**KANE PACKAGE PHILIPPINE INC.**

INVESTIGATION REPORT FORM (IRF)

Customer	INA MICRO OPTO CORP.	Attention To	WEENA APALLA
Item Code	AZ812400	Department	PRODUCTION
Item Description	CARTON	Date of Detection	241116
Job Order Number	JO-24-IPD-01058-4	Section Detected	QA SCREENING

ILLUSTRATION OF THE PROBLEM

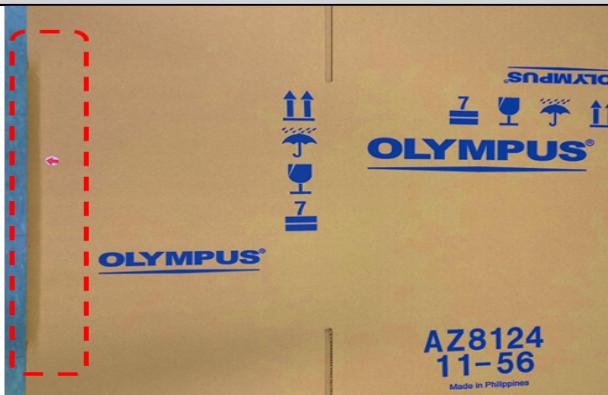
ACTUAL: With heavy extra fold up to 280 mm
REQUIREMENT: Extra fold is not acceptable

EXTRAFOLD

Heavy extra fold up to 280 mm

WHY 1 : W1 Operator conduct pre folding (hilot). r nW2 Operator is having difficulty folding along the creasing line. r nW3 Misalignment of creasing line happened that caused close and wide gap. r nW4 EQOS creasing roller hit the grain direction line of the board which is the hardest part.

Date Conducted: 2024-11-28	PIC: M.ASIS
Identified Rootcause EQOS creasing roller hit the grain direction line of the board.	Recommendation N/A

Remarks: The proposed of die-blade for this item for the improvement of creasing (the creasing impression already reached the maximum impression of 0.1mm) was declined since the item was slow moving and has small quantity.

The new corrective action from the production was re-orientation of pre-folding for this item. After the re-orientation, no extra fold issue was encountered.
